SERVICE BULLETIN

No. 739

Subject: Restriction of Flap Travel and Inspection of Wing Flap Flexible Drive Shaft

No. 739
Addendum 1

SKETCH A

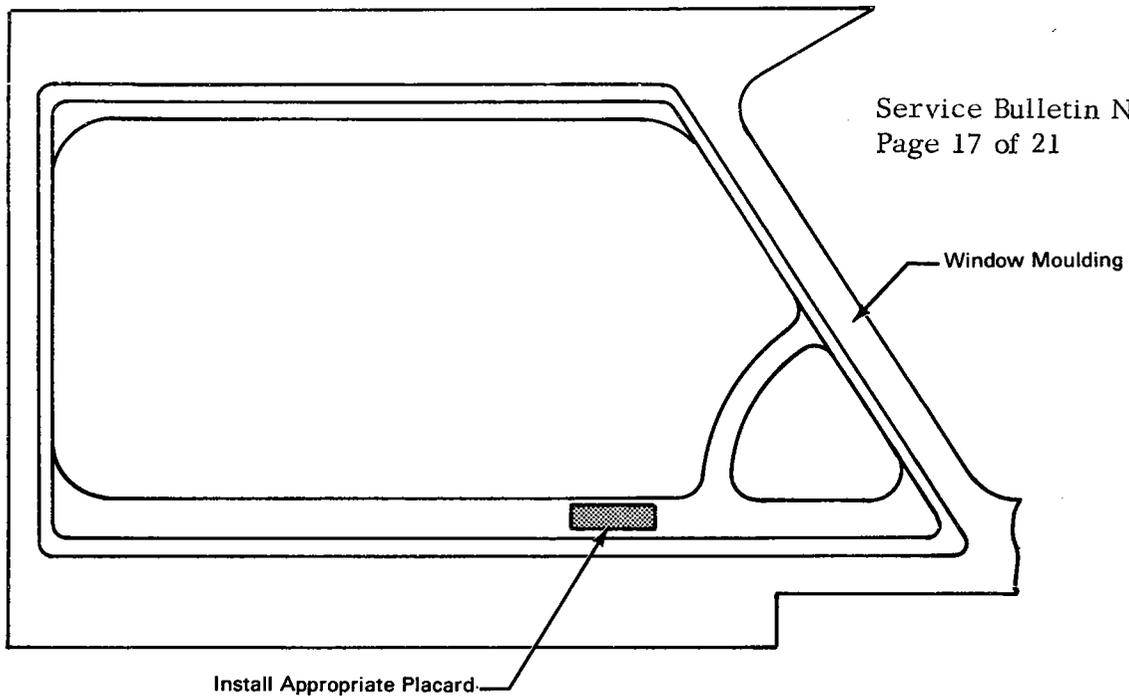
3. Paint a red full flap radial position mark to correspond with the needle position at 25° on the flap position indicator lens. Also, extend a white slippage mark from the indicator case to the lens. (Ref. Sketch A.)
4. Attach the appropriate Flap Operation Placard on the left window molding in plain view of the pilot. (Ref. Sketch B.)
5. For PA-31P aircraft attach appropriate Stall Speed Placard(s) adjacent to the airspeed indicator(s). (Ref. Sketch C.)
6. Make the necessary handwritten changes in pen and ink to the appropriate Airplane Flight Manual/Pilot's Operating Manual/Pilot's Operating Handbook as follows:
 - (a) For Piper Model PA-31-300:
 - (i) Approved Airplane Flight Manual per PAC Report No. 1470 for Model PA-31-300, Serial Nos. 31-2 through 31-511.

FIGURE 2

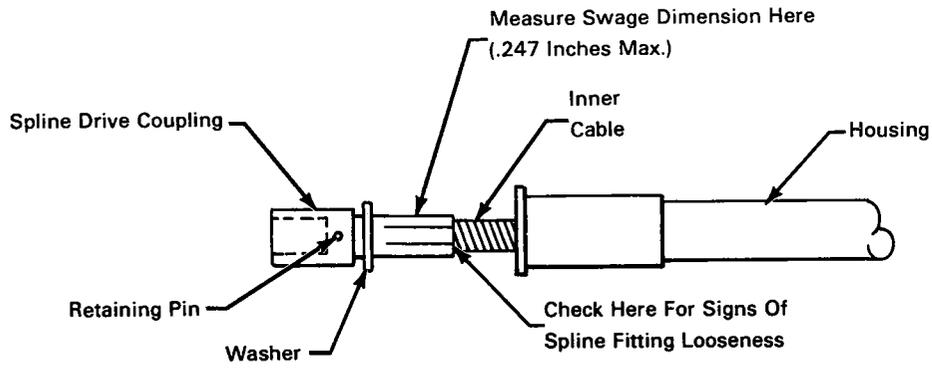
4. Visually inspect the flexible shaft splined drive coupling and retaining pin for evidence of looseness on the cable swage fitting. (Ref Sketch D, Figure 2.) If any looseness is apparent, replace the flexible shaft assembly.

5. Inspect the swaged fittings at both ends of the flexible shaft as follows:
 - a. Expose the swaged portion of the inner cable at the motor end by twisting the outer housing two (2) turns clockwise. The swaged portion of the cable should have eight (8) flats clearly visible and free from deep scratches or wear marks. (Ref Sketch D, Figure 2.)

- b. Using a micrometer, or dial caliper, measure the diameter of the swage for each of the flats at the middle of the swaged portion of the cable. A total of four (4) measurements should be taken. If any of the measurements exceed .247 inches, replace the drive shaft

- b. Using a micrometer, or dial caliper, measure the diameter of the swage for each of the flats at the middle of the swaged portion of the cable. A total of three (3) measurements should be taken for the six (6) sided swage and a total of four (4) measurements should be taken for the eight (8) sided swage. If any of the measurements exceed .235 inch for the six (6) sided cable or .247 inch for the eight (8) sided cable, replace the drive shaft.

Measure Swage Dimension Here
(.235 Inches Max. for Six (6) Flats)
(.247 Inches Max. for Eight (8) Flats)

FIGURE 4

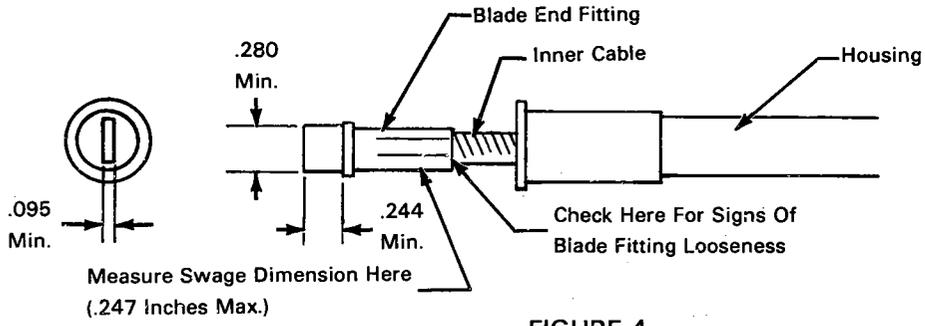
- d. Inspect the drive blade dimension as shown in Sketch E, Figure 4.

SKETCH E

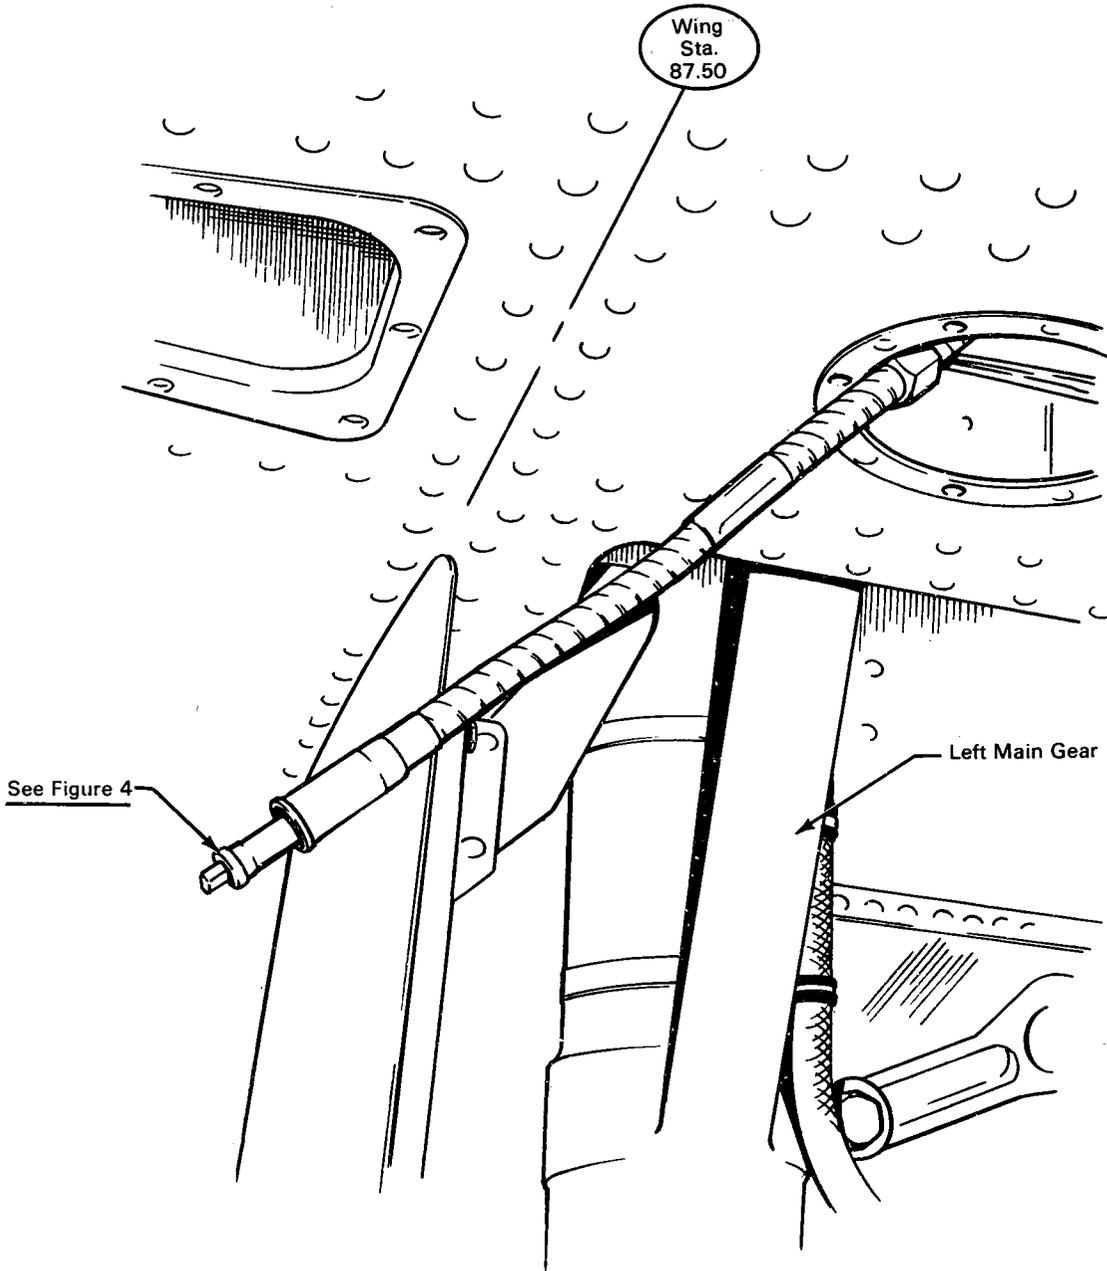
- c. Disconnect drive shaft from the flap transmission. Using caution not to damage the shaft housing, route inboard through the Sta. 87.50 bulkhead. (ref Sketch E.) Inspect the swaged portion of the drive blade fitting end as described in "a" and "b" above.

FIGURE 6

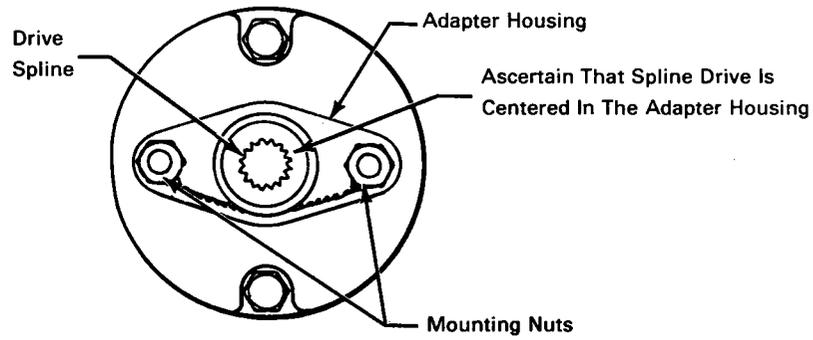
8. Determine that the inner cable moves freely within the housing, and may be turned easily by hand. If there is any snagging or binding the cable must be replaced.
9. Reassembly of the flap system:
 - a. Ascertain that the flap motor shaft is centered within the motor adapter housing (Ref Sketch F, Figure 6.).
 - b. Lubricate both ends of the flexible shafts with MIL-G-23827 grease.
 - c. Reassemble and verify flap system rigging as outlined in the Surface Controls section (Chapter 5) of the appropriate Service Manual.
10. Reinstall floorboards and access panels.
11. Log compliance with Piper Service Bulletin No. 739, PART II, in the Aircraft Logbook.

FIGURE 5

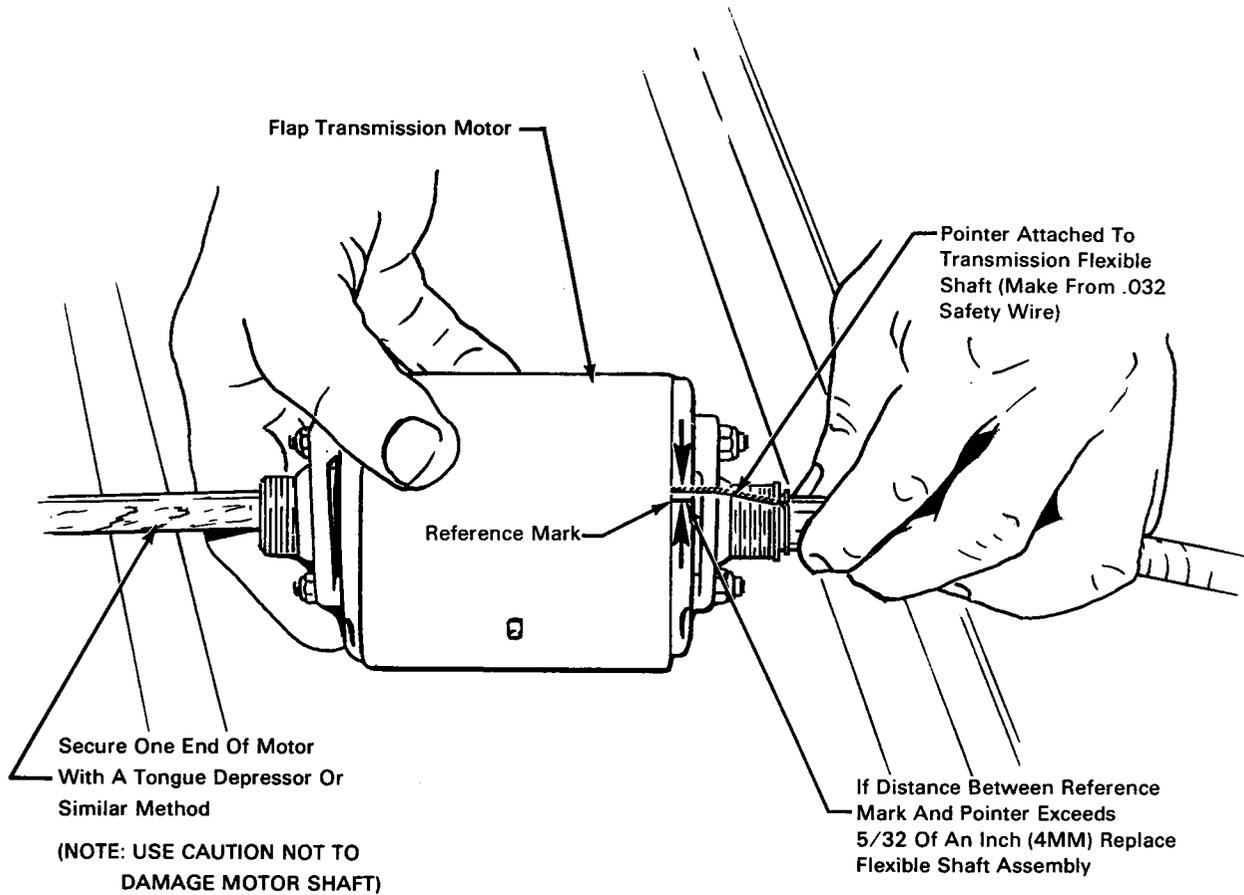
- a. Twist a piece of .032 safety wire around the swaged fitting at the motor end of the drive shaft to form a pointer (Ref Sketch F, Figure 5). With one end of the flap motor armature shaft secured engage the opposite end into the flexible shaft spline.

- b. Hold the spline end of the flexible shaft securely with one hand, and gently turn the flap motor to remove rotational play in the splines. Place a reference mark on the motor housing adjacent to the wire pointer (Ref Sketch F, Figure 5). Turn the flap motor gently in the opposite direction to remove rotational play and place another reference mark on the motor housing. If any distance between these two marks exceed 5/32 of an inch (4 mm) replace the flexible shaft assembly (Ref Sketch F, Figure 5).
